Access Compliance Report

Public Rights-of-Way

(Curb Ramps)

Intersection ID: 23277	Main Street: S_TRYON_ST	Cross Street: CAROWINDS_BV	Location: SE
ADA ID: 4BF70C66D734	Ramp Type: Perp	Initial Pass/Fail: Fail	Overall Compliance: No
Codes/Mitigation Info/Possible Solution		Field Measurements/Component Compliance	
Severity Score: 8.75

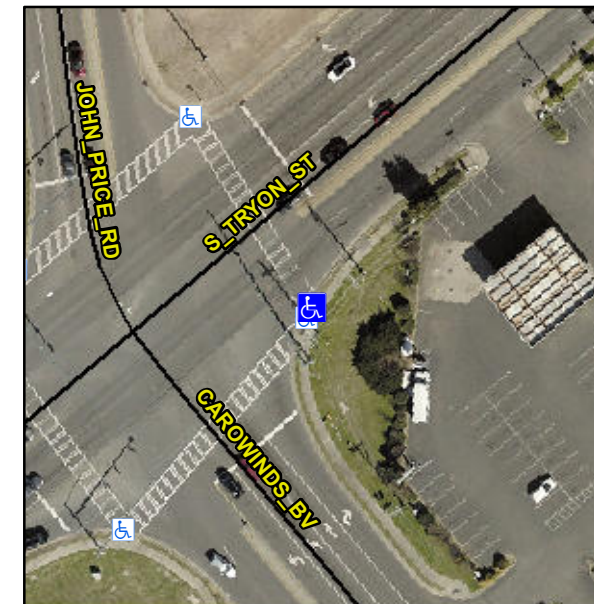
R304.5.1

Compliance	Description	Data	Compliance	Description	Data
N/A	Ramp Length (in)	54.0	Yes	Ramp Slope (%)	7.9
No	Ramp Width (in)	45.0	Yes	Ramp XSlope (%)	0.2
N/A	Flare Type LT	N/A	N/A	Flare Type RT	N/A
N/A	Flare Slope LT (%)	N/A	N/A	Flare Slope RT (%)	N/A
N/A	Flare Traversable LT?	N/A	N/A	Flare Traversable RT?	N/A
N/A	Landing Length (in)	N/A	N/A	DWS Provided?	N/A
N/A	Landing Width (in)	N/A	N/A	DWS Contrast?	N/A
N/A	Landing Slope (%)	N/A	N/A	DWS Length (in)	N/A
N/A	Landing X Slope (%)	N/A	N/A	DWS Full Width?	N/A
N/A	Landing Curb? (Y/N)	N/A	N/A	DWS Offset (in)	N/A
N/A	Shared Landing?	N/A			
N/A	Gutter Ponding?	N/A	N/A	Gutter Slope (%)	N/A
N/A	Gutter Lip Ht (in)	N/A	N/A	Gutter X Slope (%)	N/A
N/A	Painted X Walk1?	Yes	N/A	Painted X Walk2?	N/A
	X Walk 1 Direction	To N		X Walk 2 Direction	N/A
N/A	X Walk 1 Width (in)	115.0	N/A	X Walk 2 Width (in)	N/A
	X Walk 1 Slope (%)	0.5		X Walk 2 Slope (%)	N/A
	X Walk 1 X Slope (%)	0.2		X Walk 2 X Slope (%)	N/A

Remove & Replace Entire Ramp.
